UNITED STATES PATENT AND TRADEMARK OFFICE

Office Action Summary	Application No. 10/579,868	Applicant(s) MATSUMOTO ET AL.	
	Examiner ALEXANDER B. COMLEY	Art Unit 3746

2. **Claims 1-6** are rejected under 35 U.S.C. 102(b) as being anticipated by United States Patent No. 5,769,126 to Cho directed to a Discharge Valve Assembly in a Reciprocating Compressor.

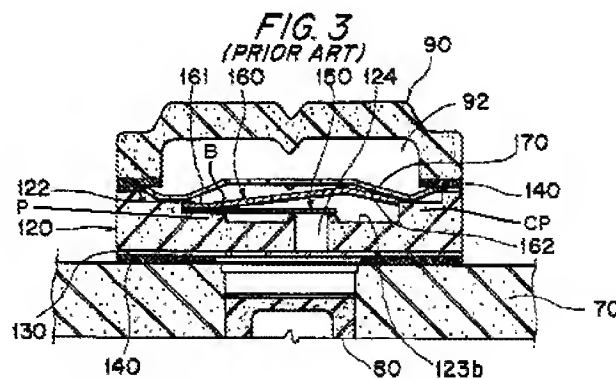
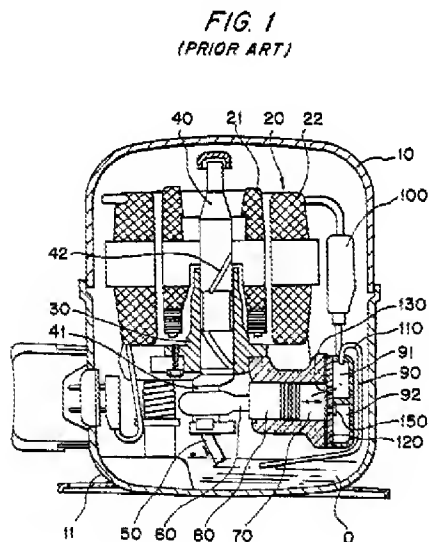
In regards to Independent **Claims 1 and 5**, and with particular reference to Figures 1 and 3 shown above, Cho discloses:

(1) A hermetic compressor (Fig. 1) comprising a hermetic container (10) that accommodates a compressing element and oil, the compressing element

comprising: a cylinder (70); a piston (80) reciprocating in the cylinder; and a valve plate (120) that seals an opening end of the cylinder and has a discharge valve system (150) at the outer side of the cylinder; the discharge valve system comprising: a discharge hole (124) formed in the valve plate; a valve seat (see Fig. 3) provided on the outer side of the valve plate around the discharge hole; a pedestal (P) formed substantially in the same height as the valve seat on the outer side of the valve plate; a plate contact portion (CP) formed at a position higher than the valve seat on the outer side of the valve plate; a discharge reed (150) made of a plate spring material and including an opening/closing portion covering the discharge hole in a way capable of opening and closing thereof and a discharge reed holding portion (see Fig. 3) fixed to the pedestal; a spring reed (160) made of a plate spring material, which includes a spring reed holding portion fixed to the pedestal (see Fig. 3) and a movable portion (162) and is provided at the outer side of the discharge reed; and a stopper (170) including a stopper holding portion fixed to the pedestal and a regulation portion and is provided at the outer side of the spring reed; wherein the spring reed has a spring reed bending portion (B) and a tip portion (162) in the movable portion, the spring reed is bent toward a direction of the valve seat at the spring reed bending portion, and the tip portion is brought into contact with the plate contact portion.

(5) A hermetic compressor (Fig. 1) comprising: a cylinder (70); a piston (80) reciprocating in the cylinder; and a valve plate (120) that seals an opening end of

the cylinder and has a discharge valve system at the outer side of the cylinder; the discharge valve system (150) comprising: a valve seat (see Fig. 3) provided on the outer side of the valve plate around a hole (124) penetrating through the valve plate; a pedestal (P) formed in the same height as the valve seat on the outer side of the valve plate; a plate contact portion (CP) formed at a higher position than the valve seat on the outer side of the valve plate; a first plate spring (150) fixed to the pedestal at one end and being capable of covering the hole at another end; a second plate spring (160) provided at the outer side of the first plate spring, fixed to the pedestal at one end and reaching the plate contact portion at another end, and bent toward the direction of the valve seat in a middle portion (B); and a stopper (170) fixed to the pedestal at one end and covering the second plate spring.

As shown in Figures 1 and 3 pictured above, Cho discloses a prior art reciprocating compressor unit (Fig. 1) that utilizes a special discharge valve setup (Fig. 3) designed to provide more efficient discharge operation. Cho's compressor is driven by a motor unit 20, which in turn drives a rotating compressing unit comprised of an eccentric 41 and piston 80. In particular, Cho states "A conventional enclosed reciprocating compressor includes, as illustrated in FIG. 1, driving means 20 having a rotor 21 and a stator 22 disposed at an upper side in an upper and a lower case 10 and 11, a crank axis 40 having an eccentric unit 41 disposed at an inner lower side of the rotor 21 through the medium of a bearing 30 and an oil pickup tube 50 disposed at a

lower end of the eccentric unit 41 for being eccentrically moved by turning effect of a crank shaft 40 and for picking up oil (o) stored at a lower side in a lower case 11 to thereby supply the oil to the eccentric unit 41 and a spiral groove 42 formed at the crank shaft 40.” (Col. 1, Lines 11-21) Cho goes on to say “The connecting rod 60 is disposed at a tip end thereof with a piston 80 for moving horizontally and reciprocally in a cylinder block 70 mounted at one side in the lower case 11. The cylinder block 70 is arranged at one side thereof with a cylinder head 90 having suction and discharge chambers 91 and 92 for high pressurized gas to be sucked in and discharged there through.” (Col. 1, Lines 27-33) Most importantly, however, is the structure of the discharge valve seen in Figure 3 of the prior art compressor. As shown in Figure 3, a discharge hole 124 with a valve seat is disposed through a valve plate 120. A pedestal (P) that is equal in height to the valve seat supports a discharge valve 150 (i.e. discharge reed), stopper valve 160 (i.e. spring reed), and keeper member 170 (i.e. stopper) on the left end of the valve plate, while a plate contact portion (CP) that sits taller than the valve seat supports the stopper valve 160 and keeper member 170 on the left side of the valve plate. To begin, Cho states “At this time, the valve plate 120 is concavely formed at an upper center area thereof with a first accommodation unit 122 for accommodating a keeper member 170 to accurately place a discharge valve 150 and a stopper valve 160 at a predetermined position.” (Col. 1, Lines 54-58) A bent portion (B) in the stopper valve 160 can be seen bent towards a direction of the valve seat, while the tip portion of the stopper valve 160 can be seen brought into contact with the plate contact portion (CP). Cho finishes by describing the operation of the discharge valve by disclosing

“Furthermore, the valve movement unit 152 of the discharge valve 150 which has blocked the discharge hole 124 is laid aside by pressure of the compressed high-pressured gas to thereby hit the valve movement unit 162 of the stopper valve 160, and the stopper valve 160 is retracted by the impact thereof until same reaches the keeper member 170, whereby the high-pressurized gas in the cylinder block 70 is discharged to the discharge chamber 92 of the cylinder head 90 through the discharge hole 124 of the valve plate 120. When the discharge of high-pressurized gas is finished and the piston 80 is moved to a bottom dead center the valve movement unit 152 of the discharge valve 150 is returned to the original position by the resilient force of the stopper valve 160 and the restoring force of the discharge valve 150, thereby contacting the discharge hole 124 of the valve plate 120 and the hole 124.” (Col. 2, Lines 32-58)

3. In regards to dependent **Claim 2**, the discharge valve 150 (i.e. discharge reed) bends between the left-end holding portion and the freely moving right end tip portion of the valve, thereby forming a bent portion in between that is bent toward a direction of the valve seat. Regarding dependent **Claims 3 & 6**, it can be seen in Figures 2 & 3 that a concave portion lower in height than both the valve seat and pedestal is formed between the valve seat and the pedestal on the valve plate (See Fig. 3). And finally, in regards to dependent **Claim 4**, the keeper member 170 (i.e. stopper) is shown with a stopper contacting portion that is bent towards the stopper valve 160 (i.e. spring reed) (See. Fig. 3).
